Addendum No. 03

September 11, 2025

SUCF Project No. 221038-00

Renovate Pioneer Center

PREPARED FOR: STATE UNIVERSITY OF NEW YORK COLLEGE OF TECHNOLOGY AT ALFRED	RENOVATE PIONEER CENTER				
	PREPARED BY:  POPLI DESIGN GROUP 170 FRANKLIN ST, 8TH FLOOR BUFFALO, NY 14202 716-625-9200	JOB NO:	22.014	DATE:	09/05/2025
		DRAWN BY:	SRF	SCALE:	N.T.S.
		ADDENDA#3		CSK-006

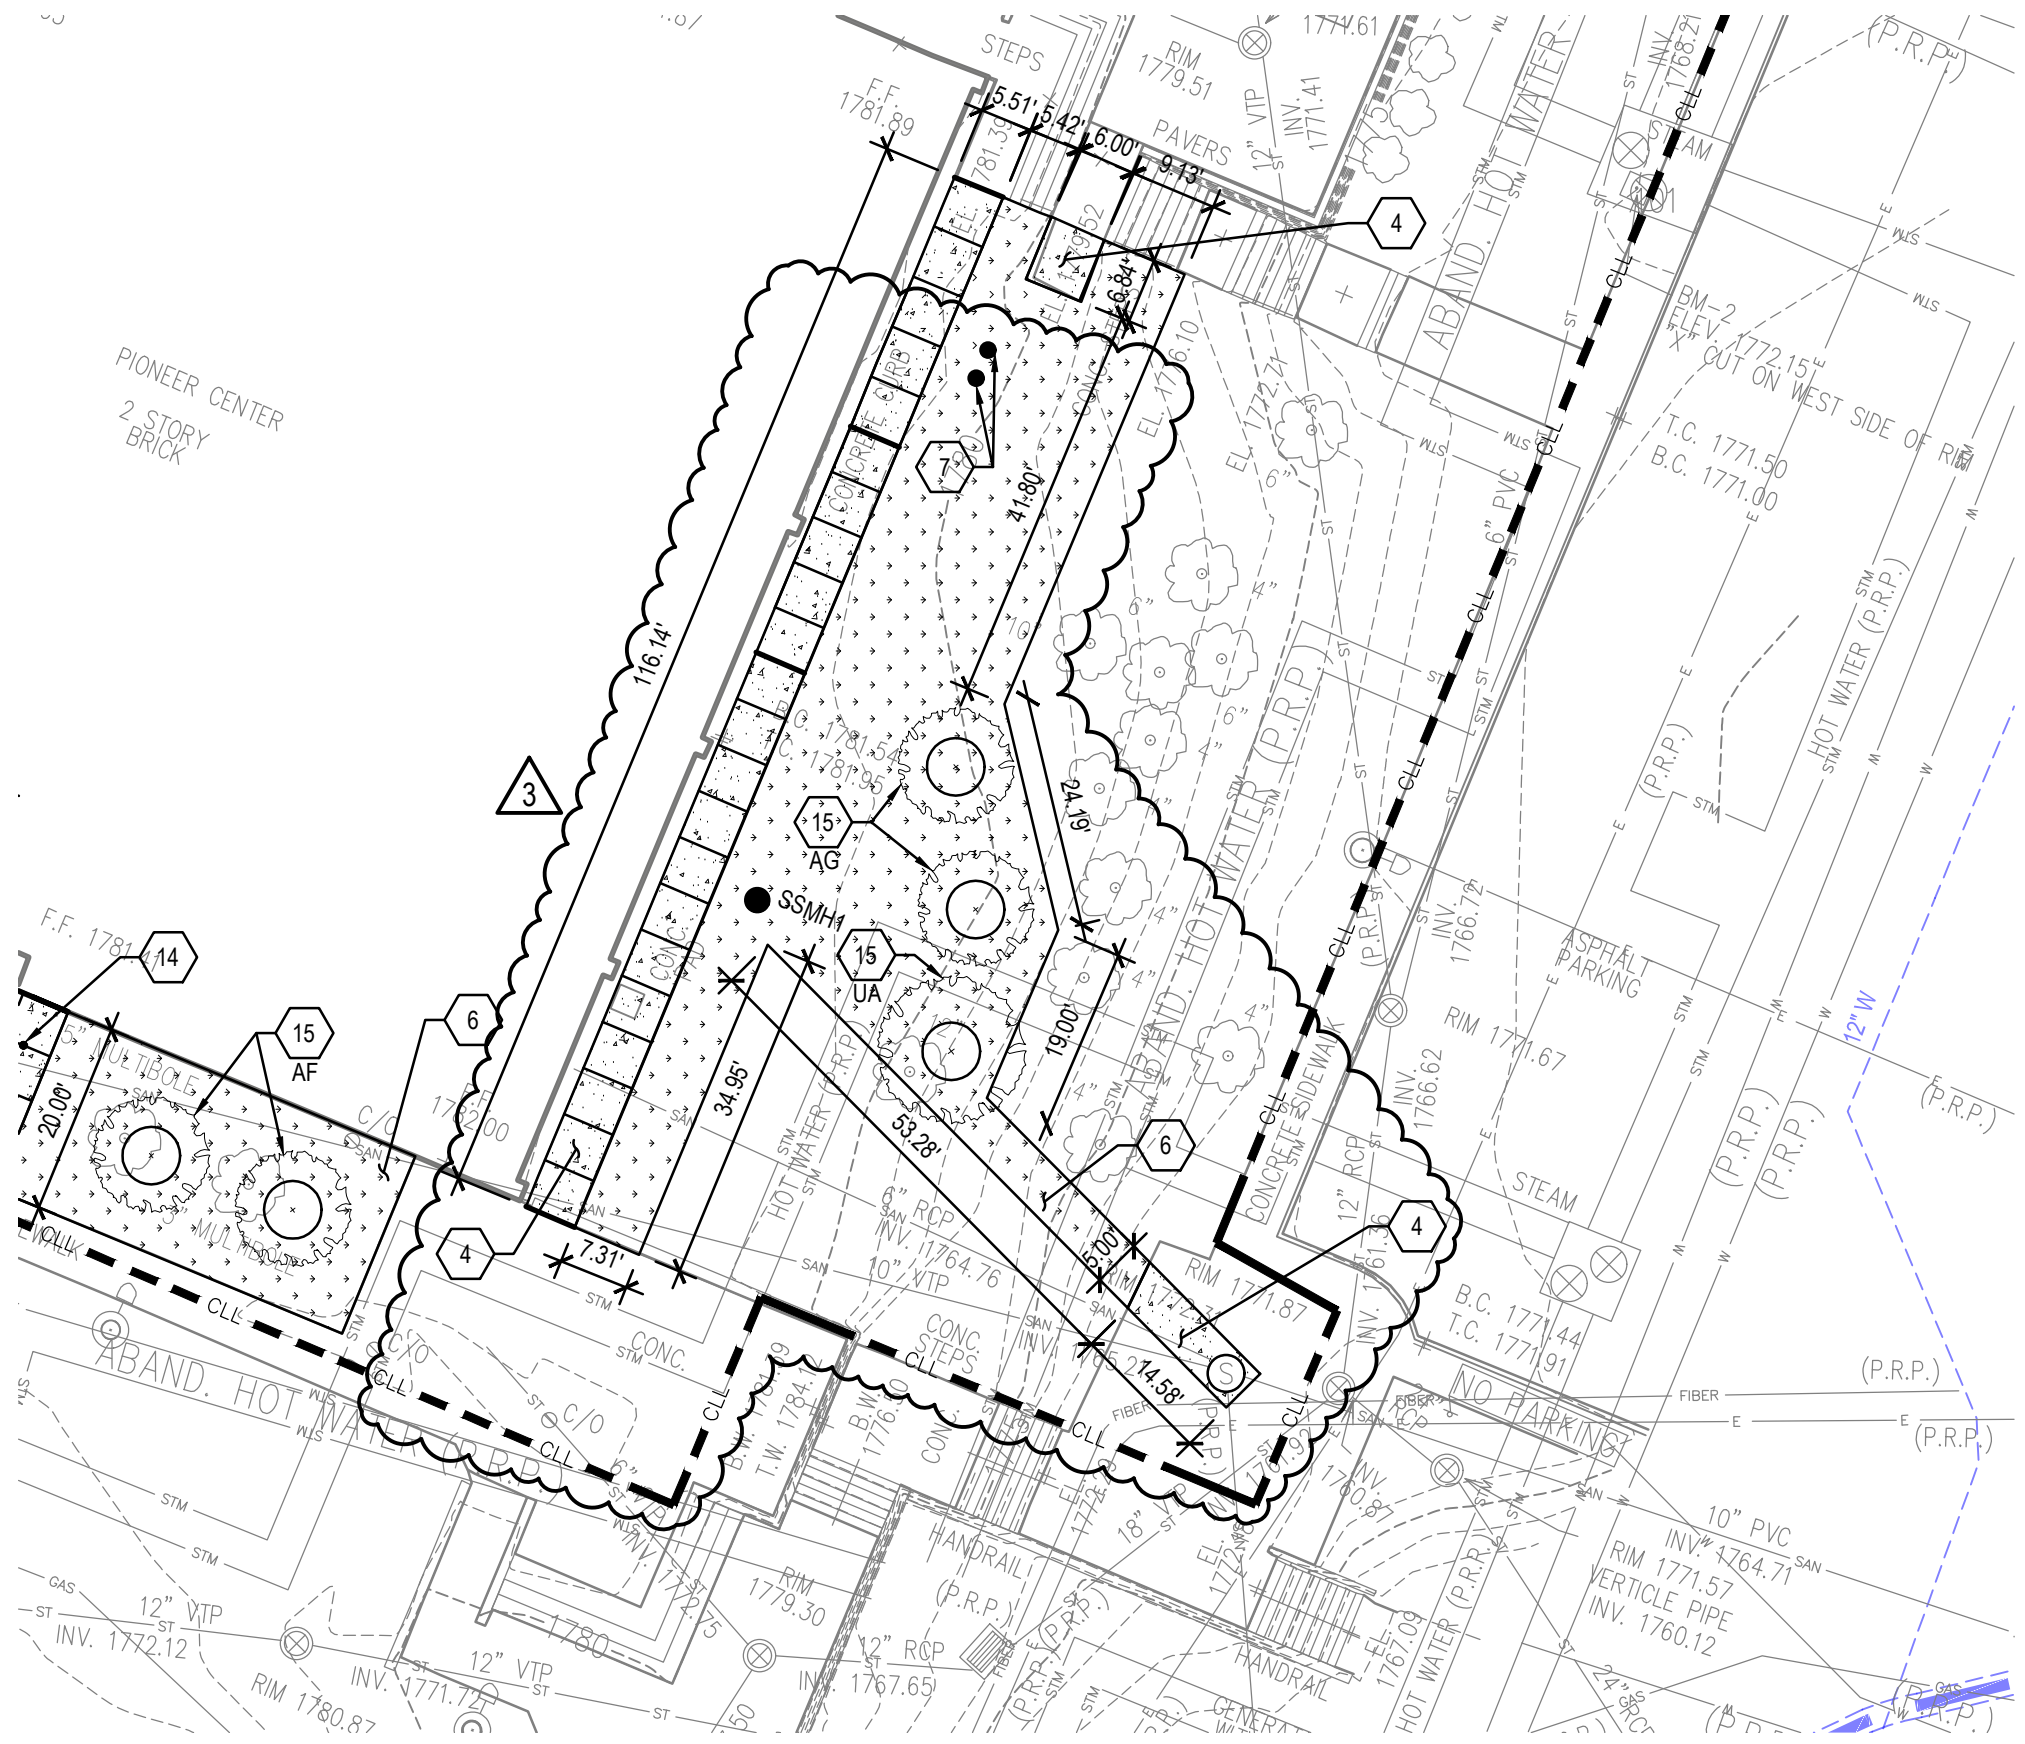
Revise: Site layout as indicated on attached drawings CSK-005 and CSK-006.

PREPARED FOR: STATE UNIVERSITY OF NEW YORK COLLEGE OF TECHNOLOGY AT ALFRED		RENOVATE PIONEER CENTER		
PREPARED BY: POPLI DESIGN GROUP 170 FRANKLIN ST, 8TH FLOOR BUFFALO, NY 14202 716-625-9200	JOB NO: 22.014		DATE: 09/05/2025	ADDENDA#3
	DRAWN BY: SRF		SCALE: N.T.S.	CSK-007

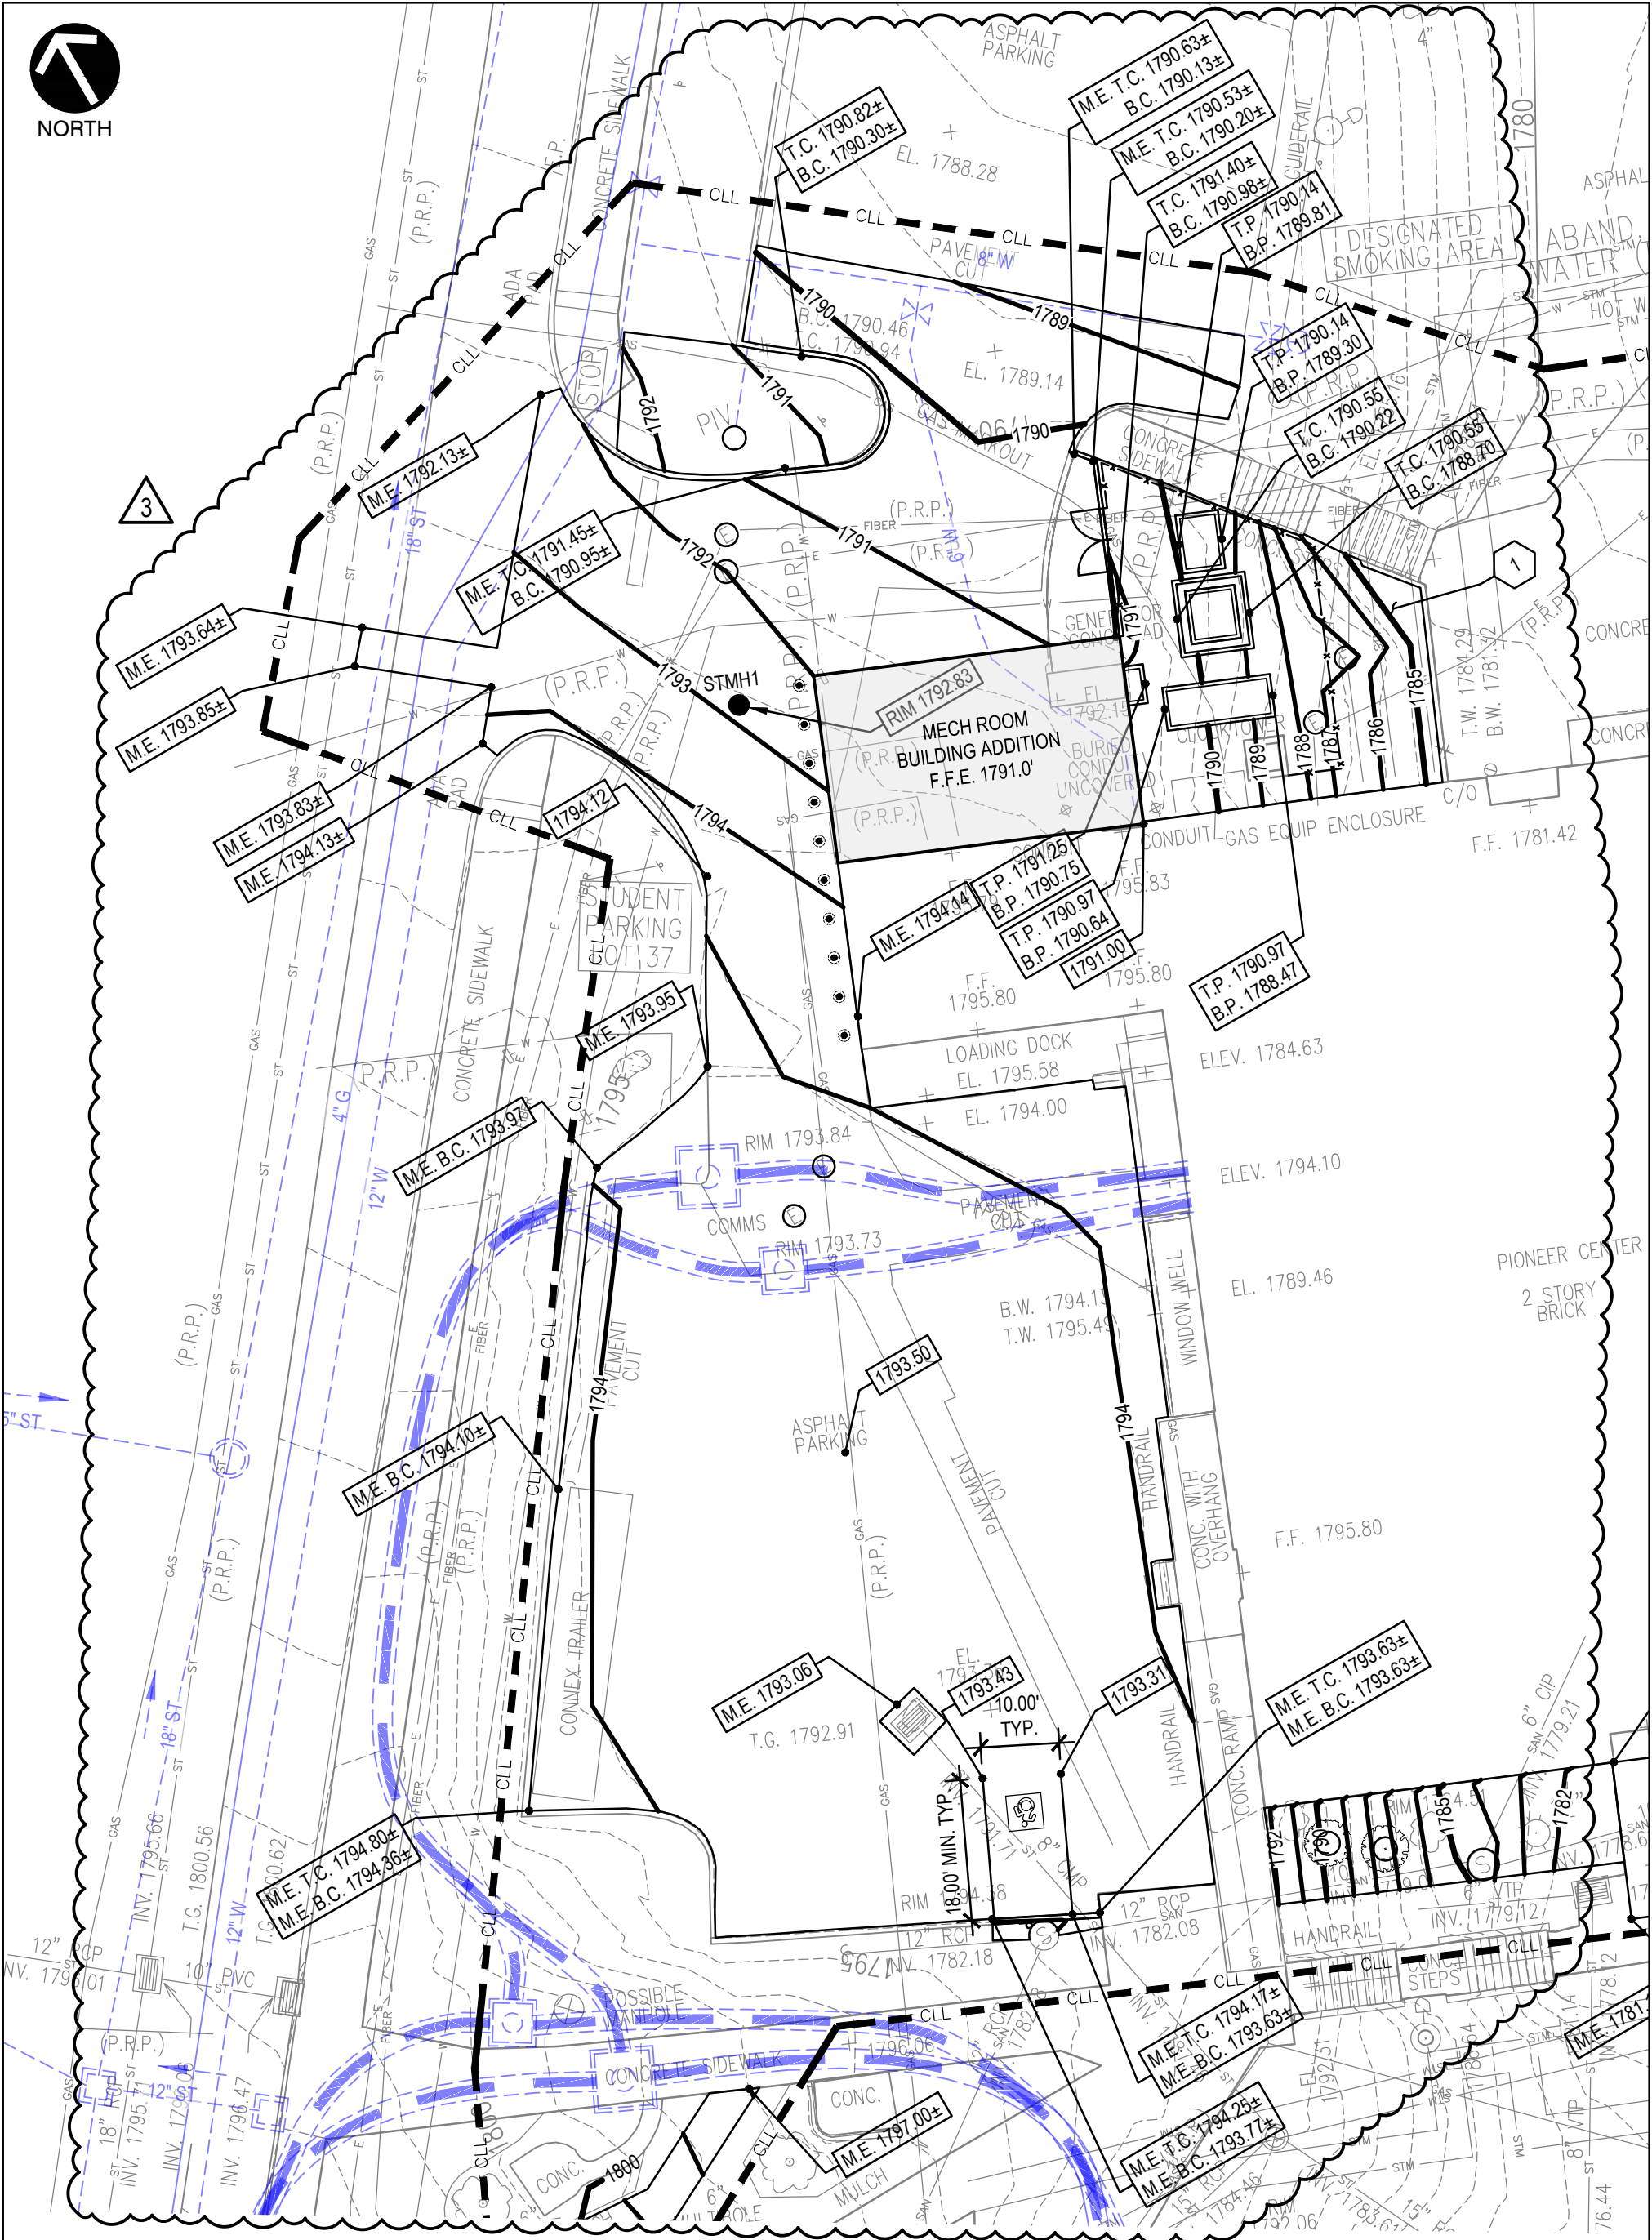
Revise: Site grading as indicated on attached drawings CSK-007 and CSK-008.

PREPARED FOR: STATE UNIVERSITY OF NEW YORK COLLEGE OF TECHNOLOGY AT ALFRED		RENOVATE PIONEER CENTER		
PREPARED BY: POPLI DESIGN GROUP 170 FRANKLIN ST, 8TH FLOOR BUFFALO, NY 14202 716-625-9200	JOB NO: 22.014	DATE: 09/05/2025	ADDENDA#3	
	DRAWN BY: SRF	SCALE: N.T.S.	CSK-009

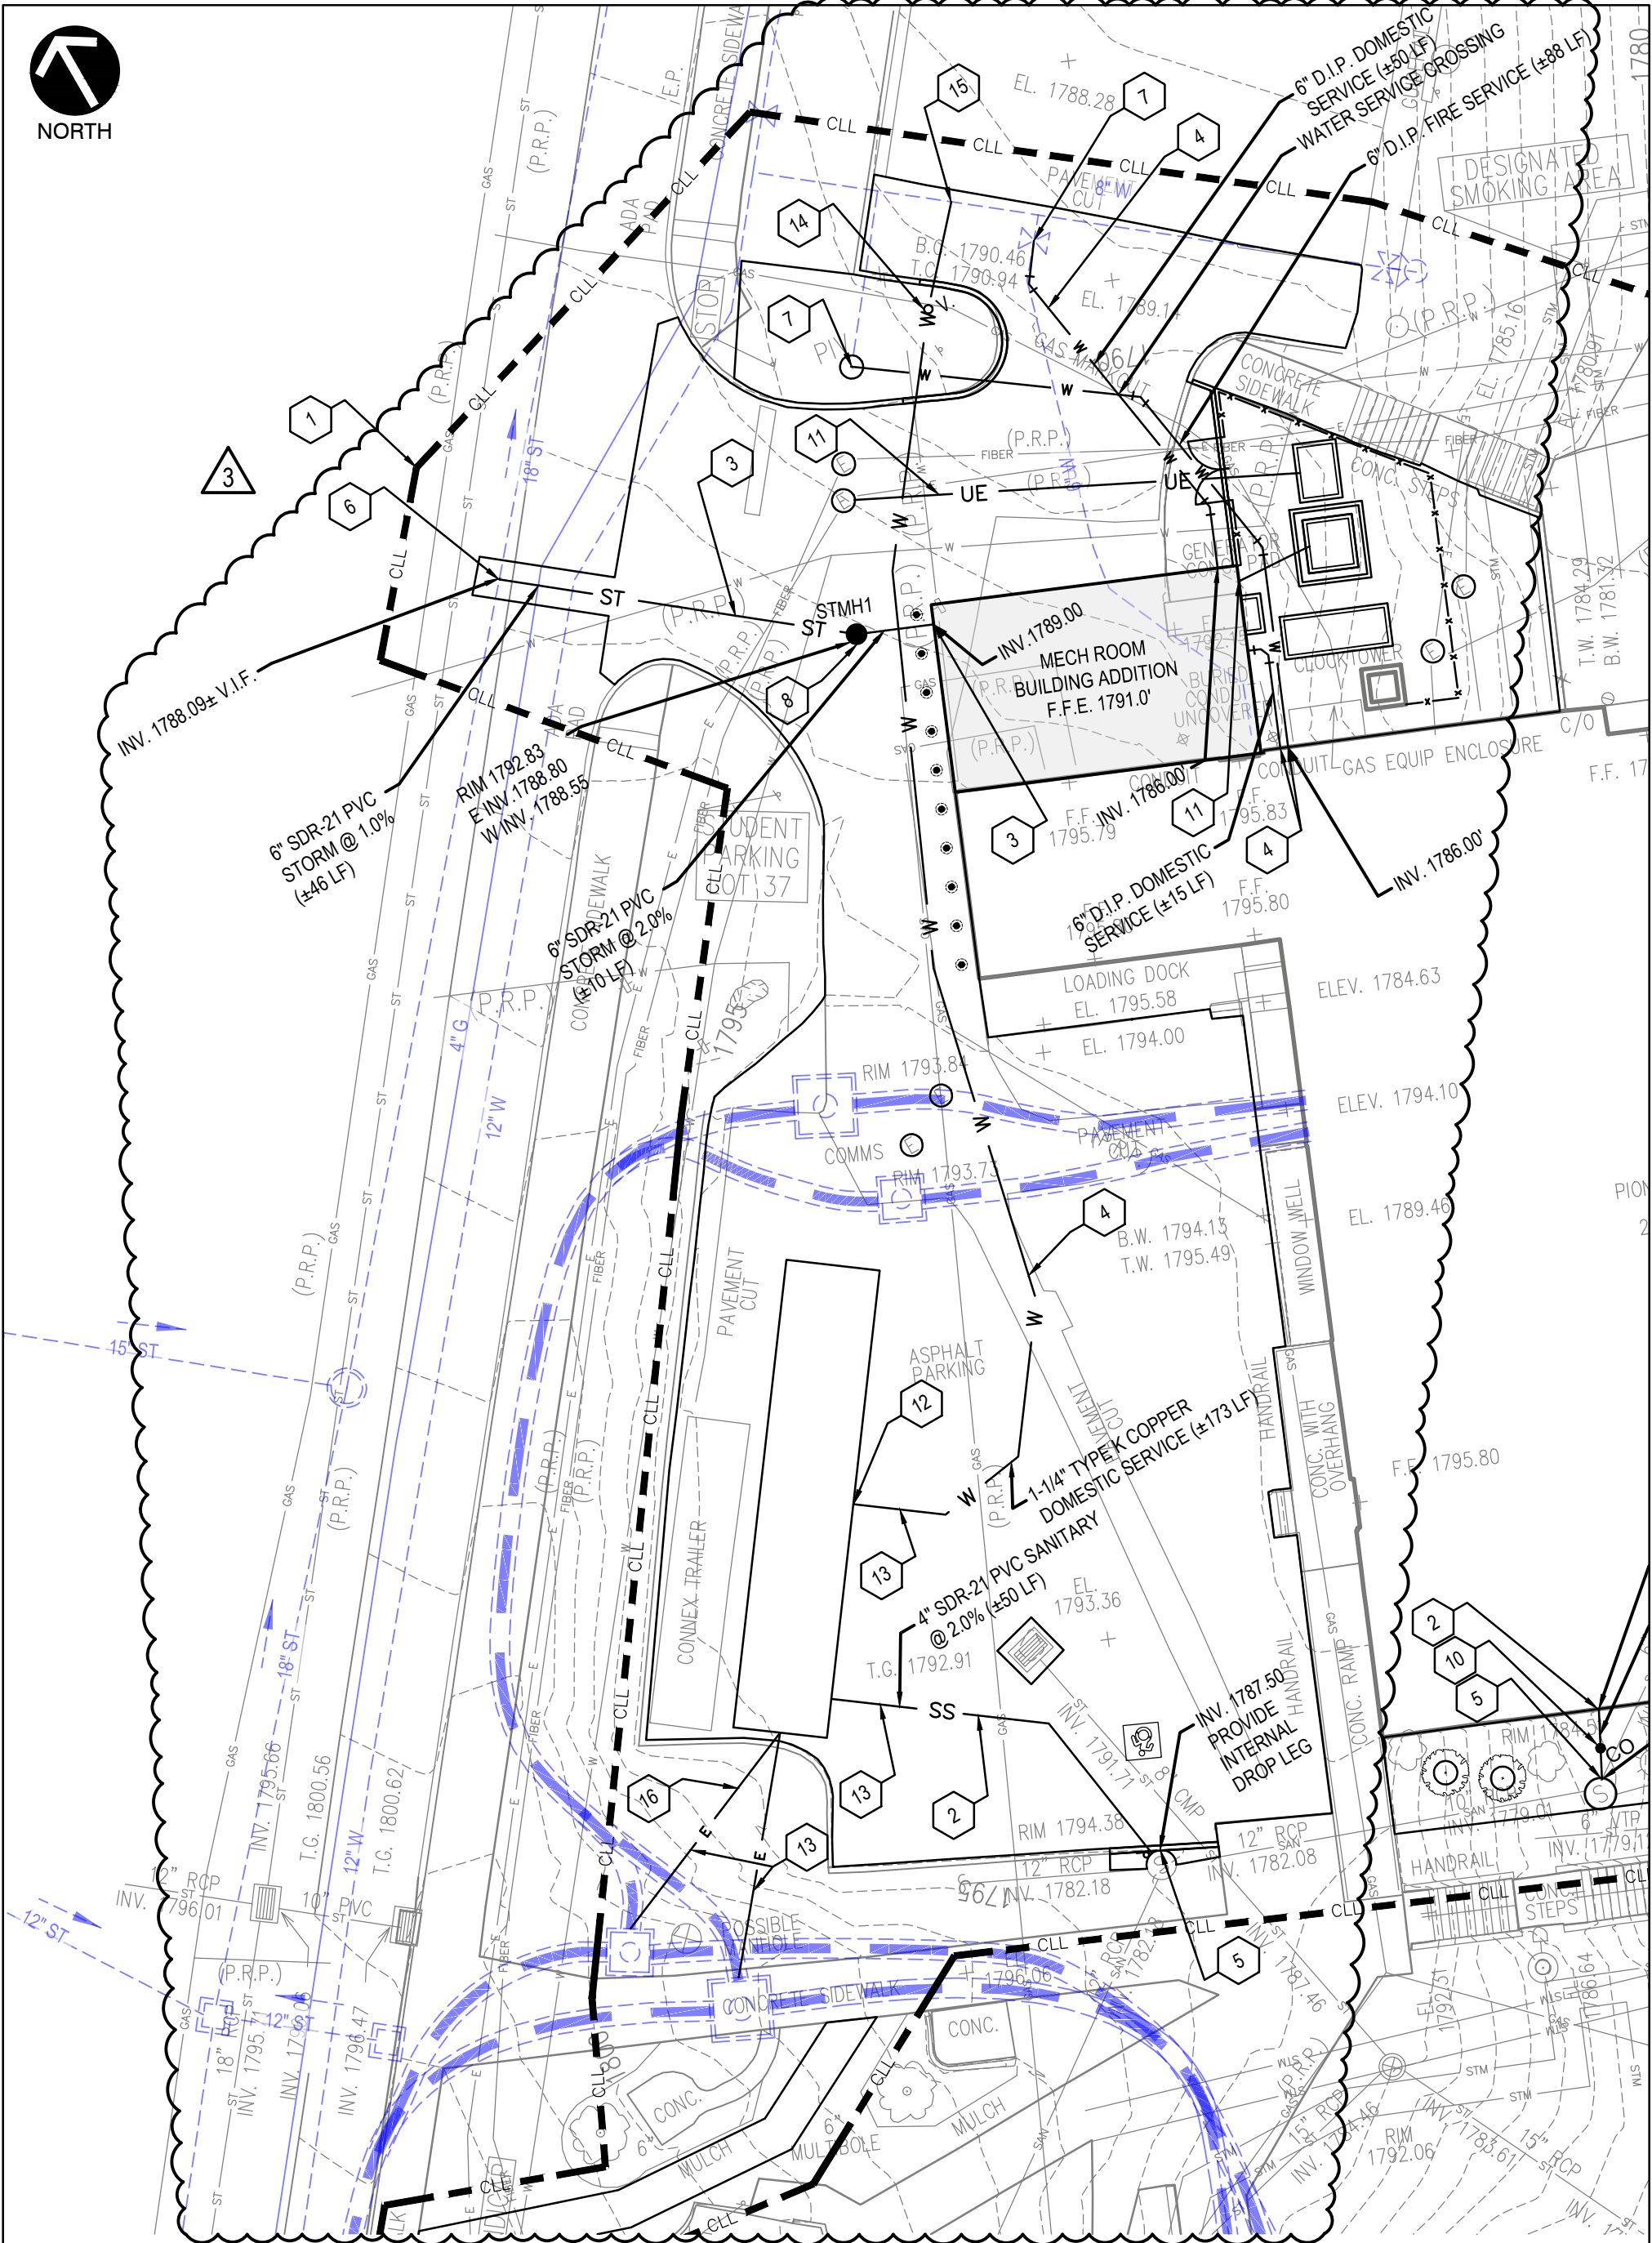
Revise: Site utilities as indicated on attached drawings CSK-009 and CSK-010.
